P02	19/05/23	Response to RFI
P01	28/04/22	Issued for Planning
Revision Number	Date	Drawn
Issues & Revisions

**Project Details:**  
 Dalguise  
 Monkstown

**Drawing Title:**  
 Proposed Elevations + Sections - Block D

MKS-RAU-D-ZZ-DR-AR-200	Revision
	P02

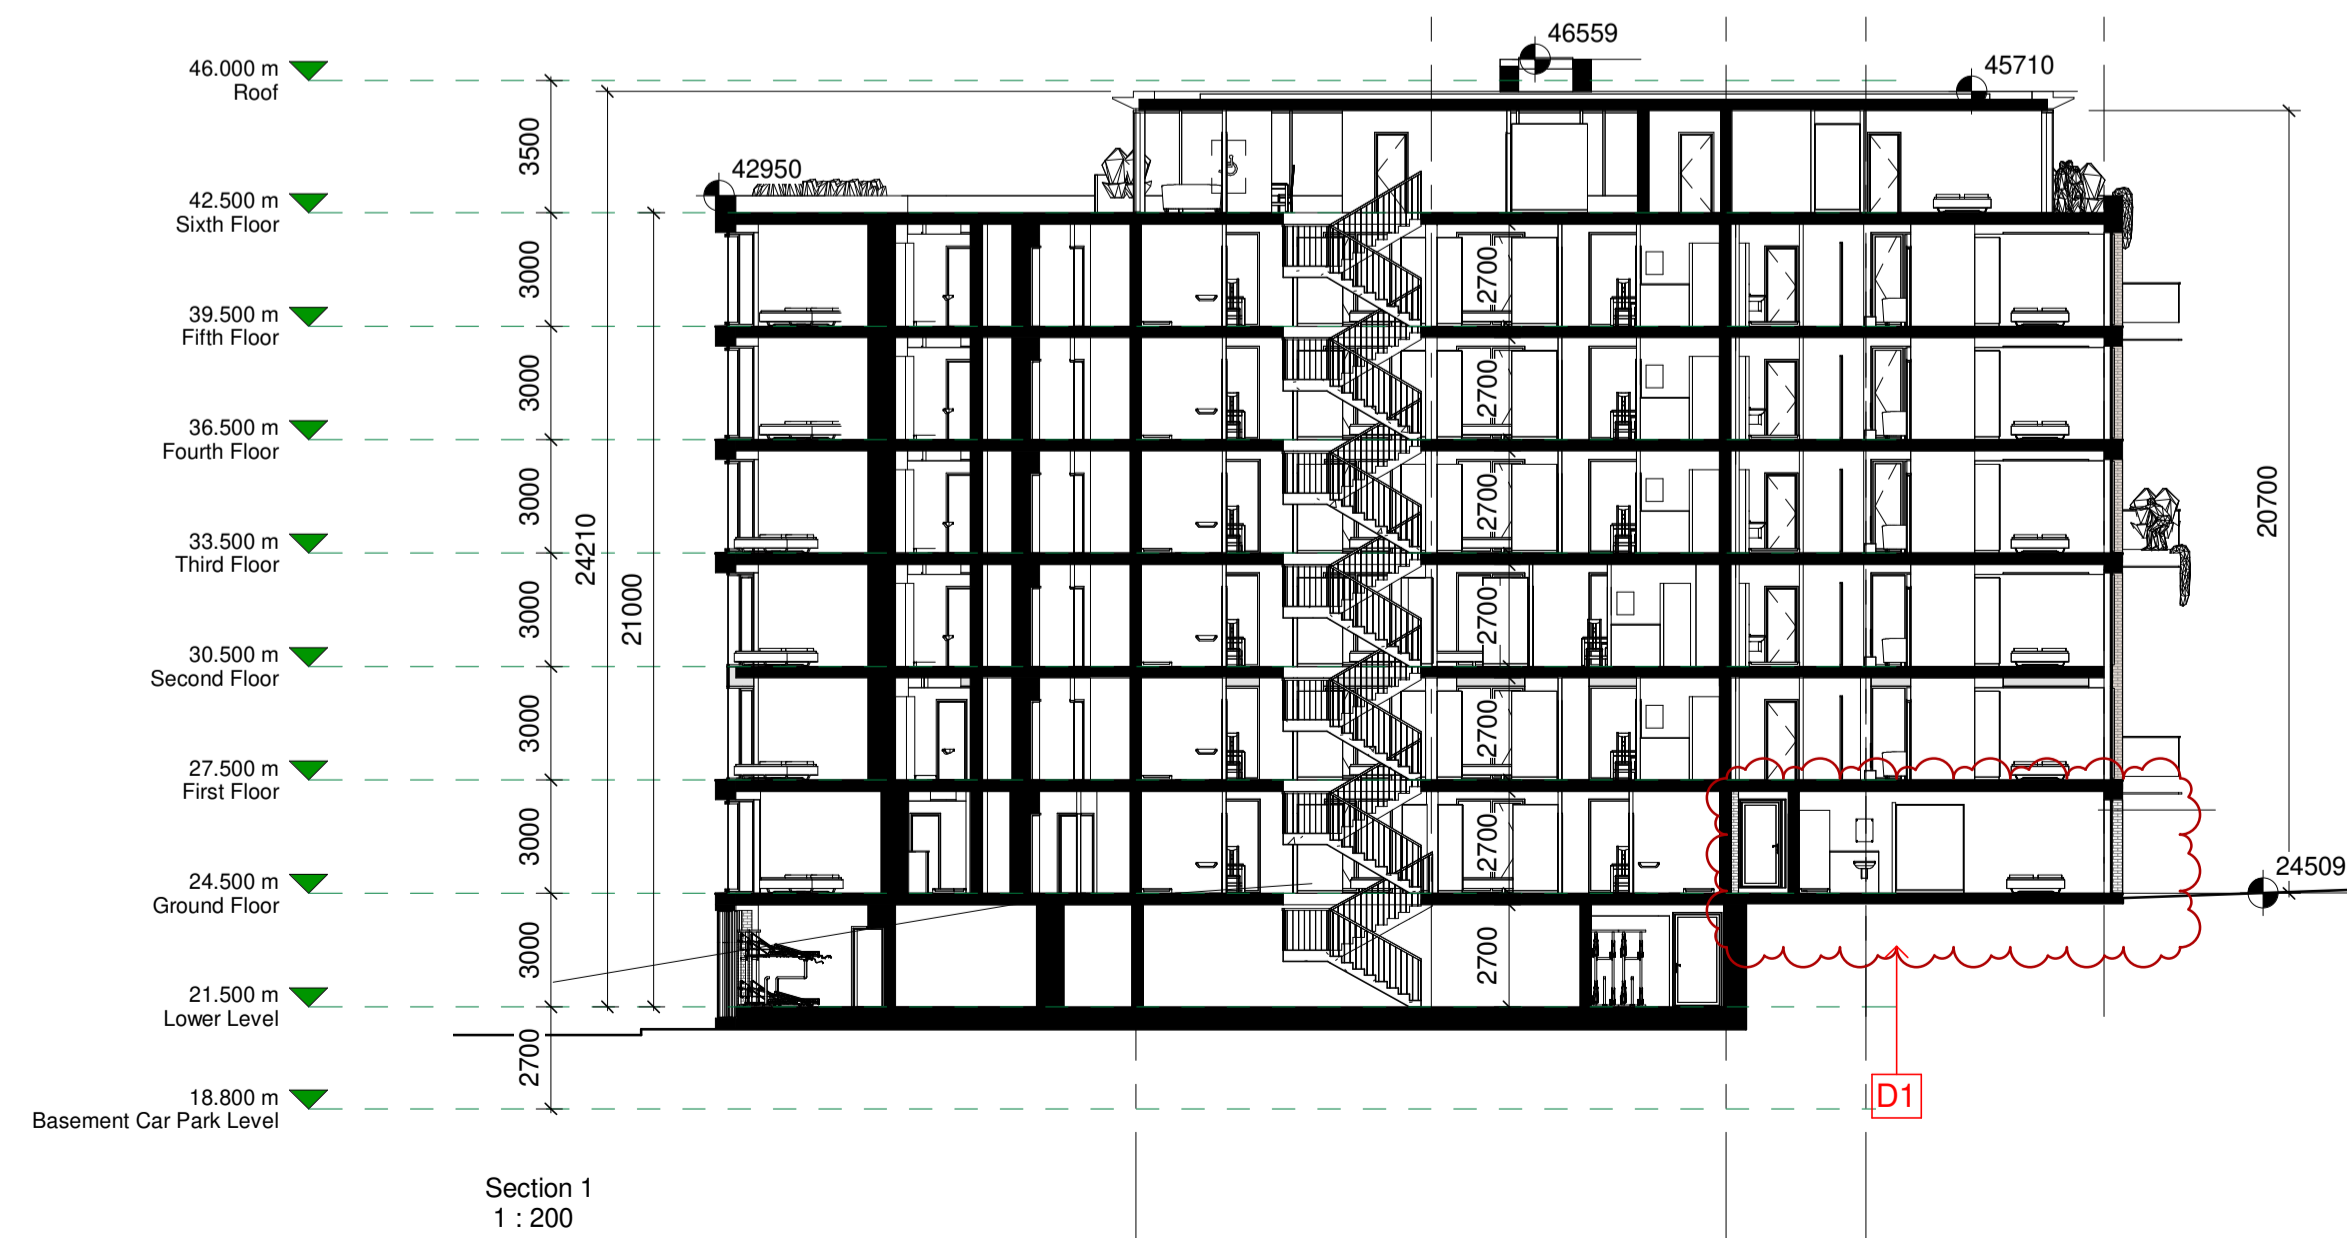
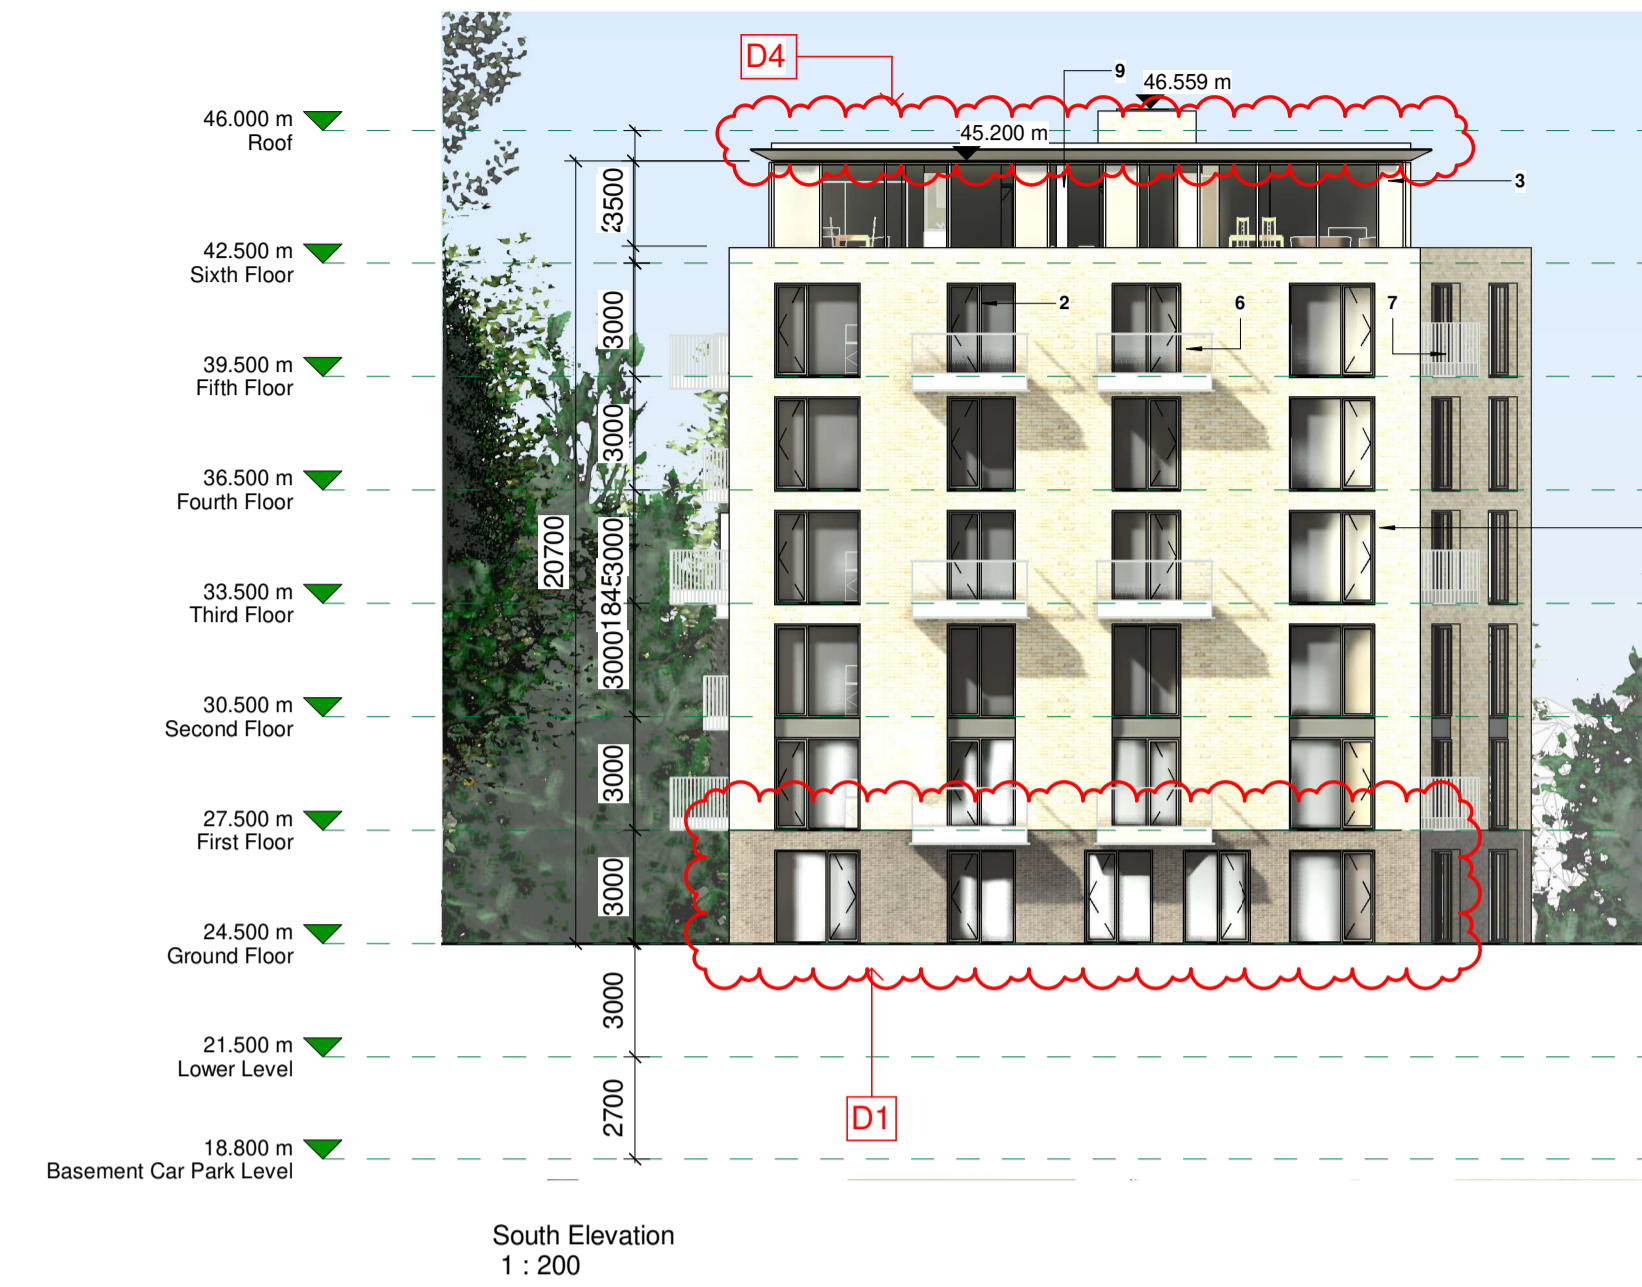
- D1. New Entrance added.
- D2. New 1 Bed Apartment added in lieu of Car Park Entrance Ramp.
- D3. New 3 Bed (5p) Apartment added in lieu of Car Park Entrance Ramp.
- D4. Minor alterations Roof Profile
- S6. Bicycle Entrance Widened with new separate access cycle route to Basement cycle stores
